Commonwealth Edison

Subject: LaSalle County Station Unit 1
Requested Additional Information
Regarding SRV Blowdown Test
NRC Docket Nos. 50-373

Attachments (1): Sargent & Lundy Responses to Request for Additional Information Regarding SRV Blowdown Test dated 9/27/84
(2): Wyle Laboratories Extended Blowdown Transient Plots.

RESPONSE TO REQUEST FOR ADDITIONAL INFORMATION
REGARDING SRV BLOWDOWN TEST

SKETCH OF SENSOR ORIENTATION
IN LASALLE UNIT 1 SUPPRESSION POOL
(0.5 cm = 1'-0")

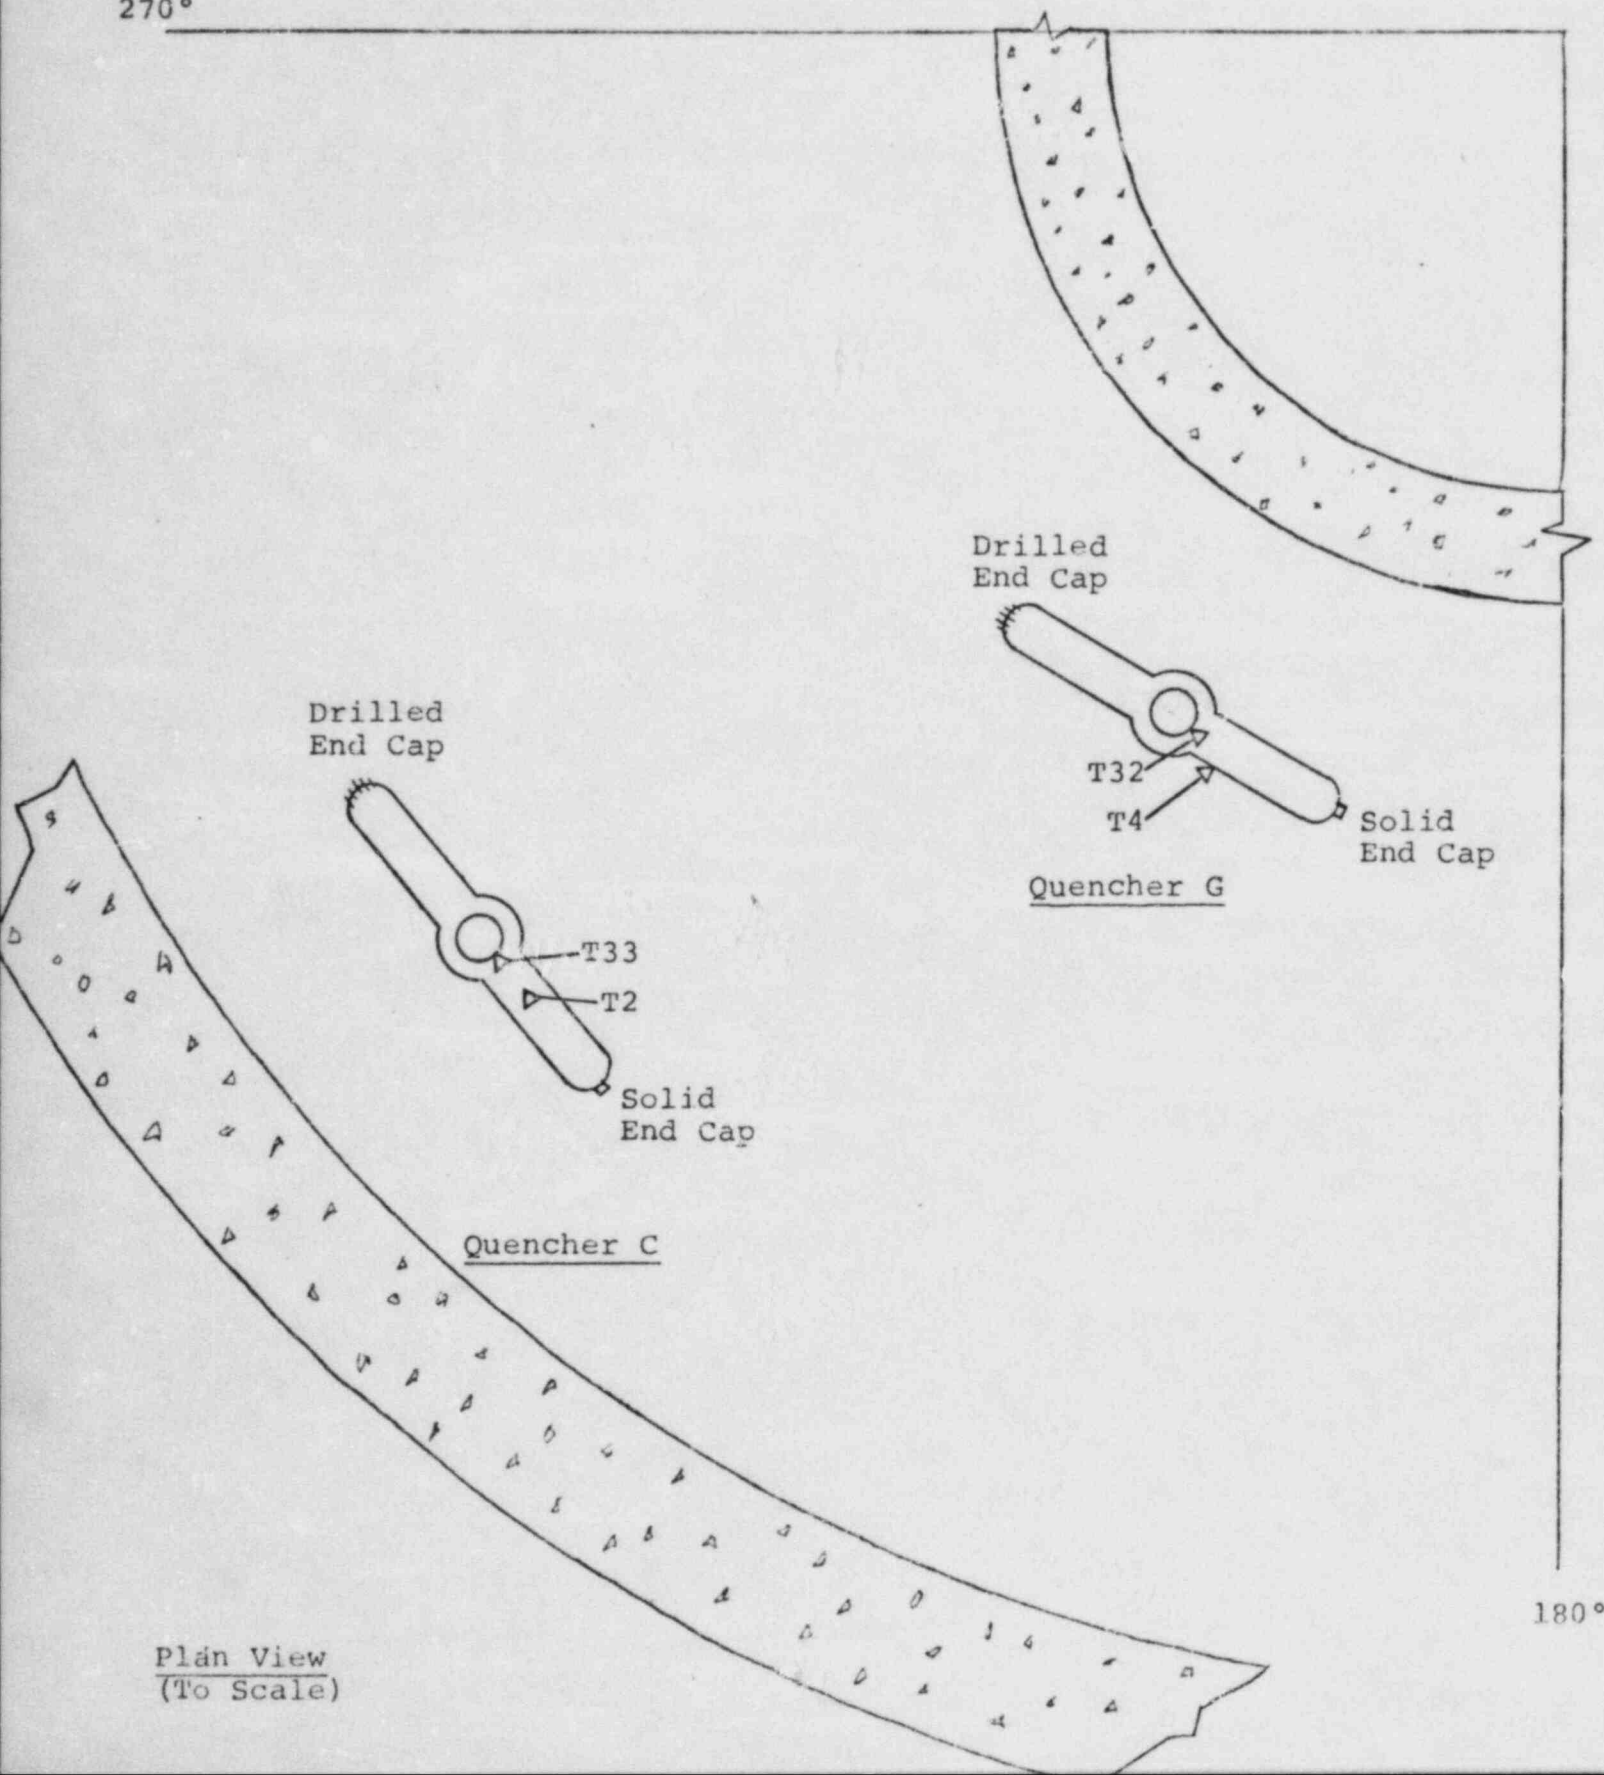
This response provides the information requested in the A. Schwencer letter of August 17, 1984 [1]. Attachment 1 is a sketch of the test temperature sensor locations relative to the quencher end cap holes. Attachment 2 is a set of recorded temperature responses for all the sensors. These plots were prepared by Wyle Laboratories.

We agree with this characterization of the general flow pattern surrounding a discharging quencher. Consequently the sensors chosen to represent the local pool temperature were those mounted directly above and below the quencher. Other sensors were not used because:

While it may be permissible to use these sensors, NUREG-0783, as previously mentioned, supercedes these guidelines and clearly states a preference for more locally mounted sensors. These were the sensors used in the computations of local-to-bulk pool temperature (e.g., T2, T4, T32, T33).

3) The four sensors used to compute local pool temperature (two per quencher) were mounted upstream of the quencher centerline relative to the bulk pool motion induced by steam discharge from the end caps as well as by RHR flow. These sensors were mounted in this location to better measure the temperature of the inflowing water. It has been correctly pointed out that sensors mounted downstream of the quencher center would have provided a more conservative measure of the local-to-bulk pool temperature difference. However the following points should be noted
